Water Eaton Development: PR6a: Planning Application - 23/01233/OUT

Connectivity to Oxford Road A4165 and Cutteslowe Roundabout ITB16565-SK-074 Oxford Road Cycle improvements (South)

Pipal Cottage

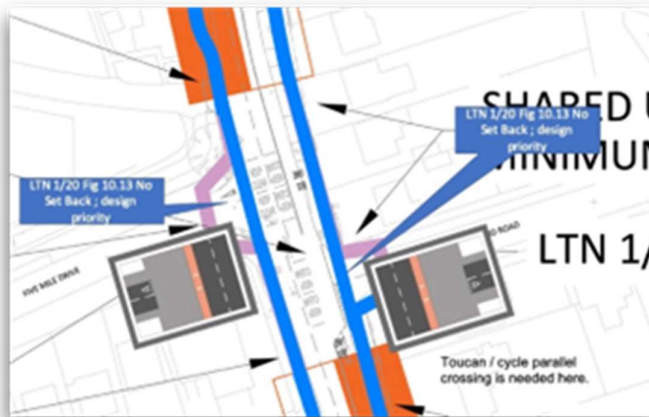
We recognise that there is a major problem with the cycle and footpaths as they pass Pipal Cottage

The reality is that the desire line for pedestrians walking to and from Oxford Parkway along this route will be straight across, using the cycle way, creating conflict. If the full PR6b scheme requires land to the west of Oxford Road, then this should accommodate a slight re-alignment of Oxford Road to the west to allow a full, direct full-size segregated cycleway and pedestrian path on the east side and thus avoid a pedestrian diversion past Pival. In the interim, pending the full PR6b scheme, then the widest possible shared use would be acceptable, appropriately signed, with designs that are future proofed to anticipate improvements at this point that the PR6b scheme can bring.

Side road crossings

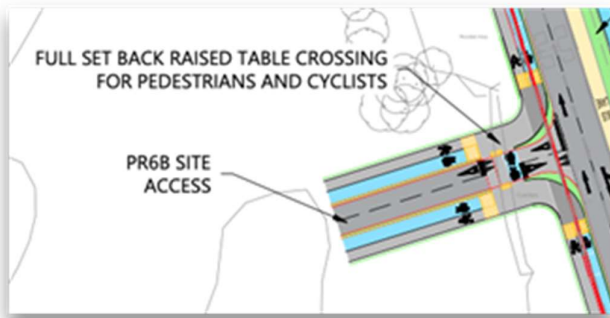
We believe that cycle path and pedestrian crossings of side roads should be *no set back design priority* as per LTN 1/20 Figure 10.13. The cycle paths constitute a key commuter route to and from Oxford and deviations and delays should be designed out.

The side road entries of Five Mile Drive and Harbord Road should also be *no setback design priority* as per LTN 1/20 Fig 10.13.

The crossing of the access to PR 6b should be designed in the same way, i.e. *no set back design priority* – not as shown on the application drawing above.
